STATE OF NORTH CAROLINA
DEPARTMENT OF TRANSPORTATION

May 1, 2020

Subject: Revised Modification Request for the Section 404 Individual Permit and Section 401 Water Quality Certification for the proposed Havelock Bypass in Craven County. TIP No. R-1015. Debit \$ 570 from WBS 34360.1.2

PERMIT DRAWING SHEET 35 OF 167

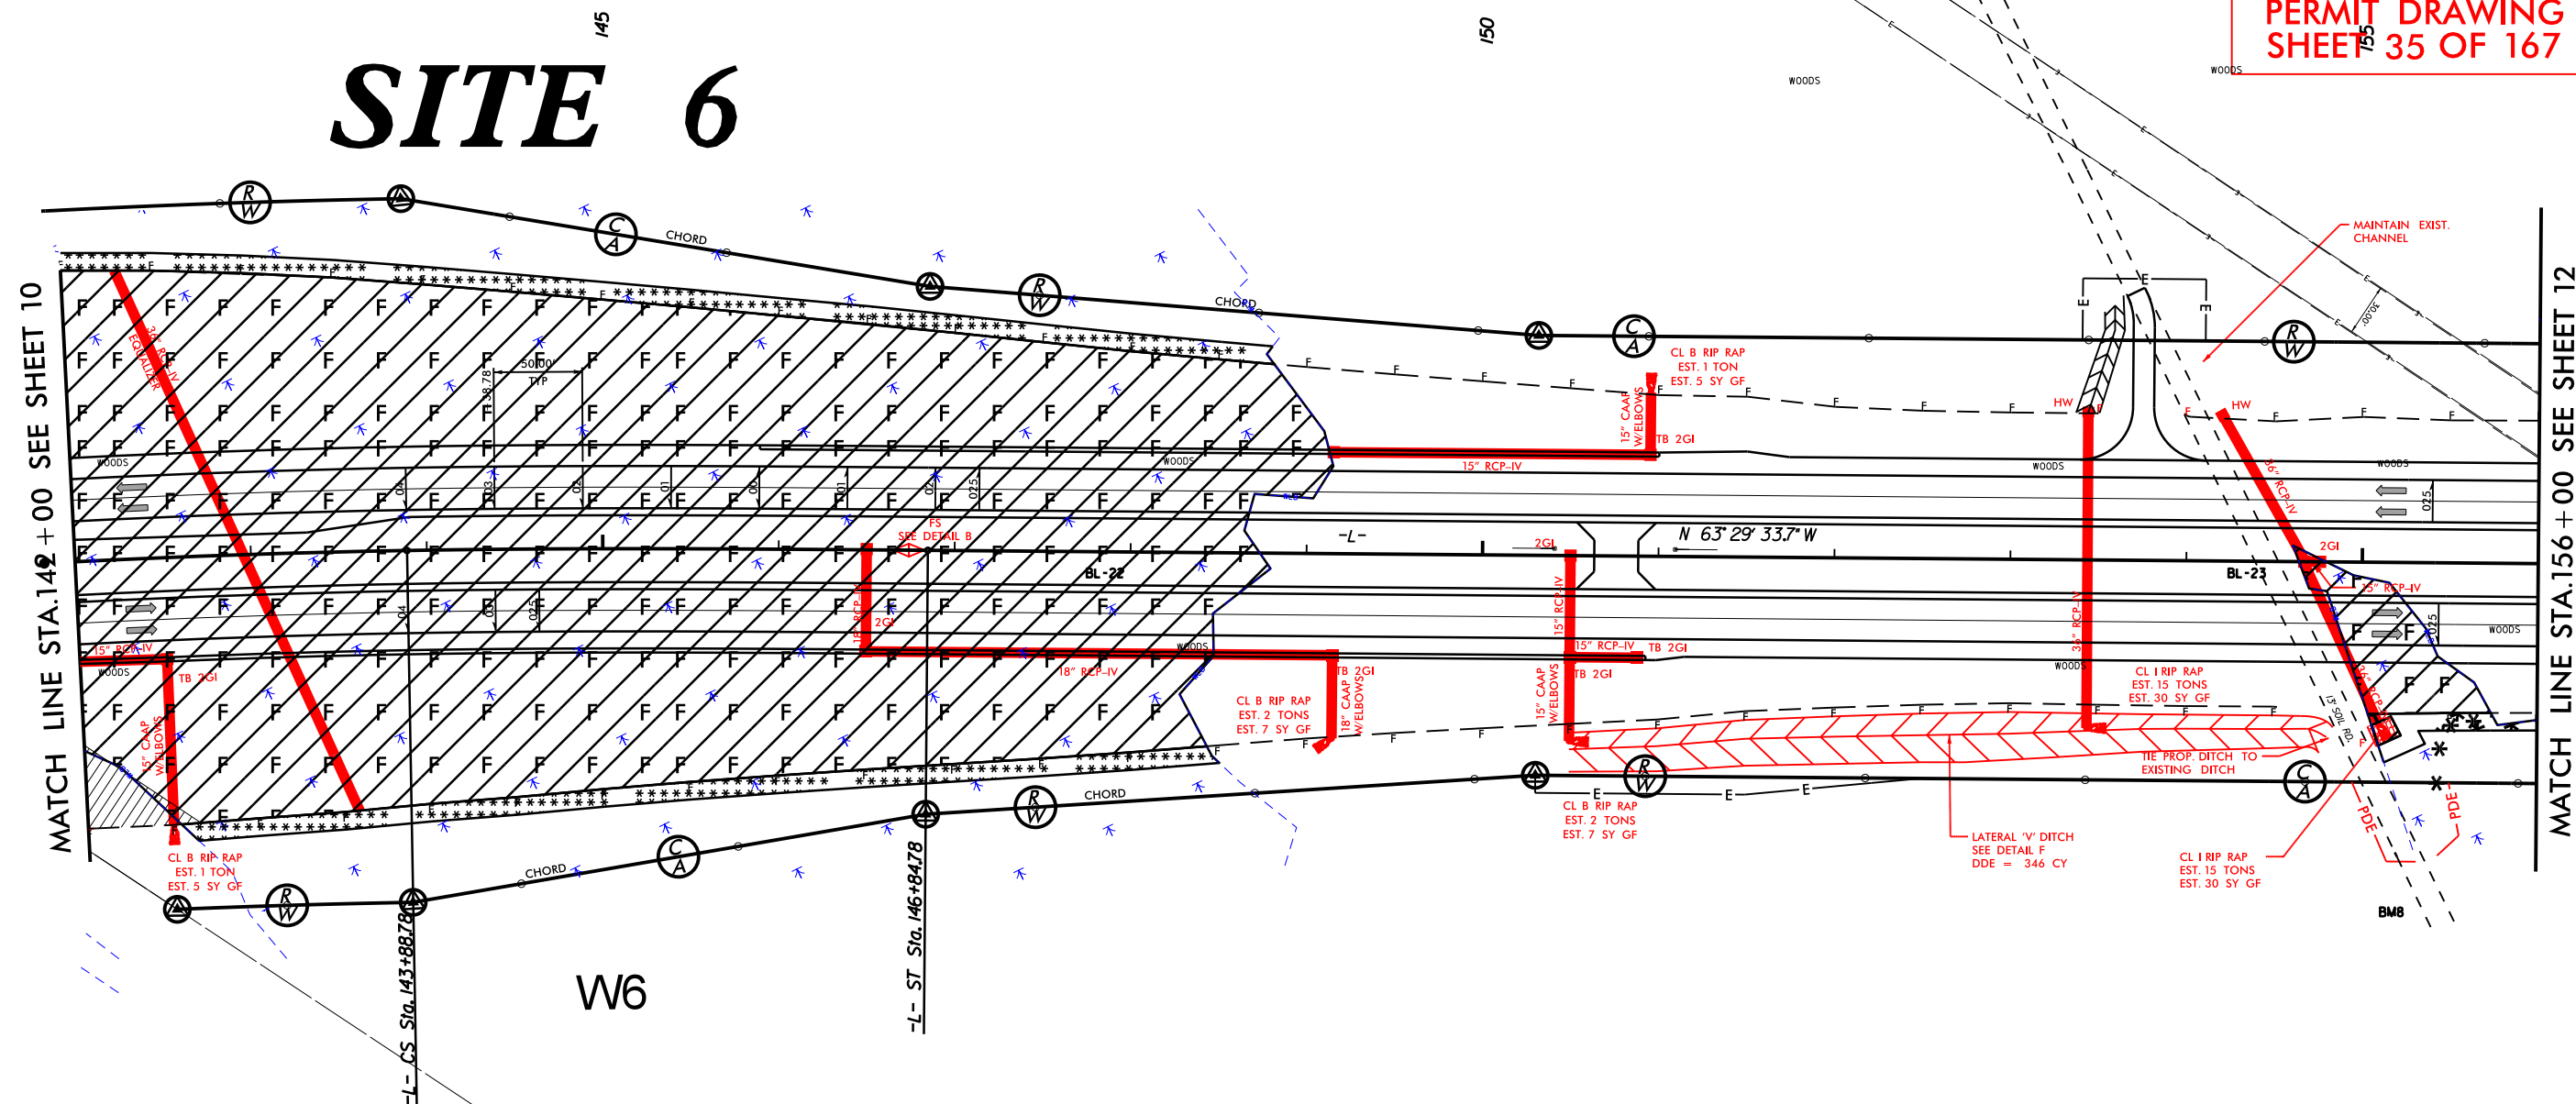
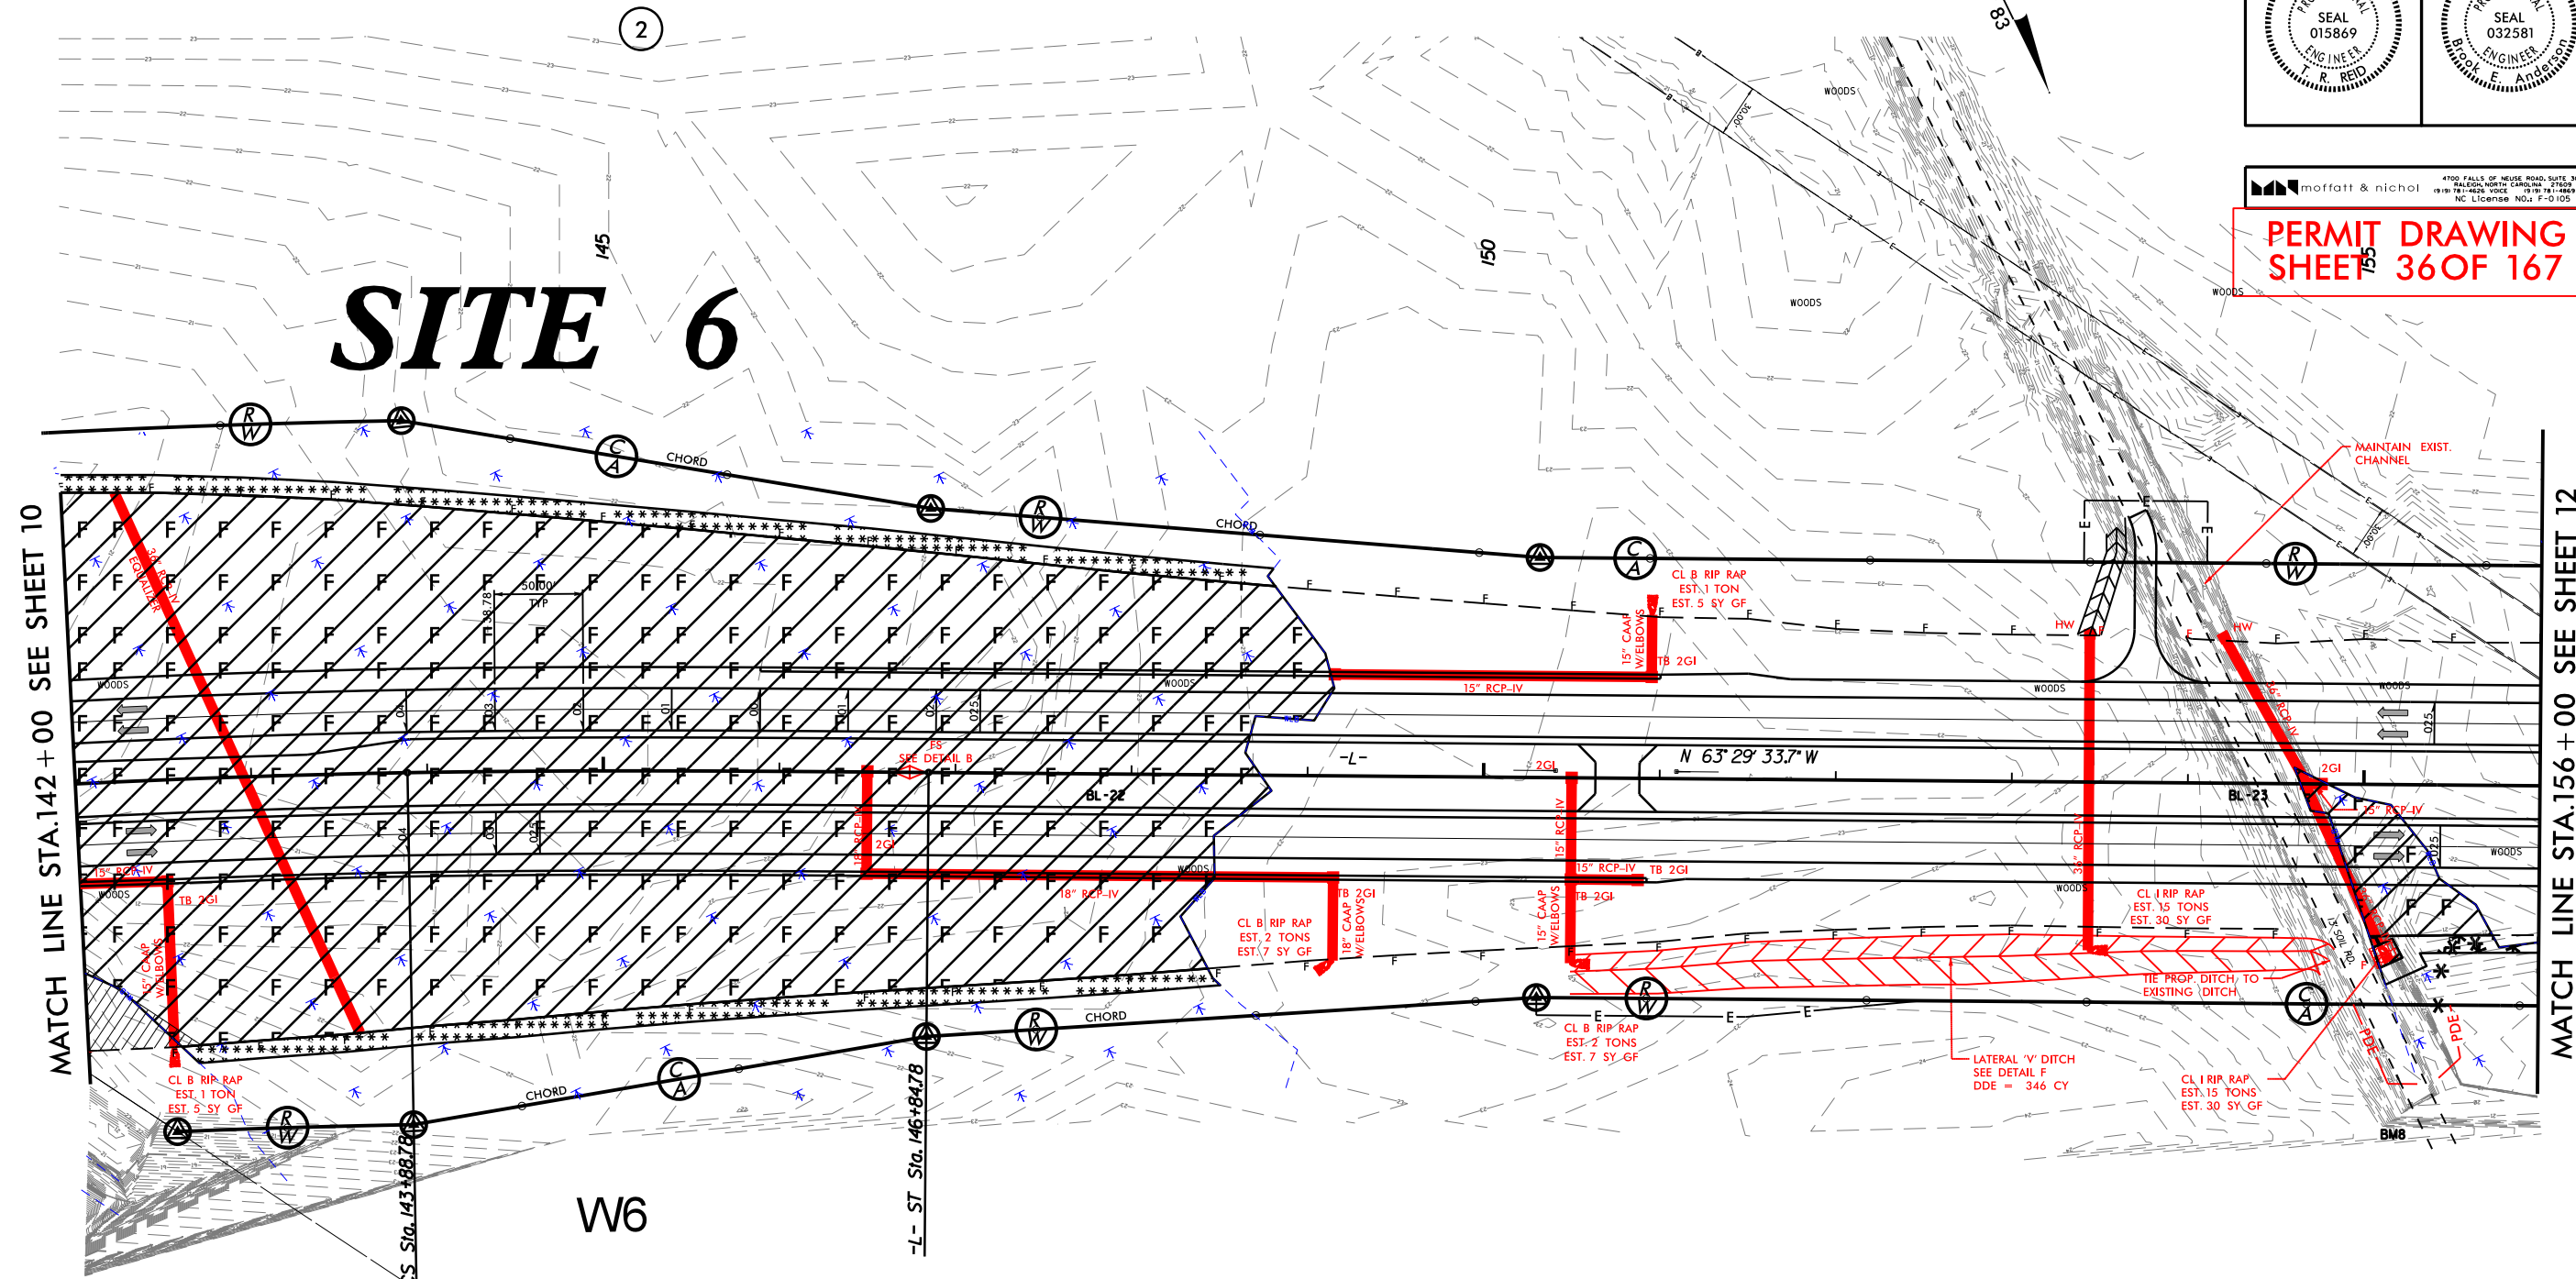
- **Site 7: omitted in 3/12/20 modification request, (permit sheets 35 & 36). Access driveway was removed. Fill in wetlands reduced by 0.04 acre. Mechanized Clearing reduced by 0.01ac.**
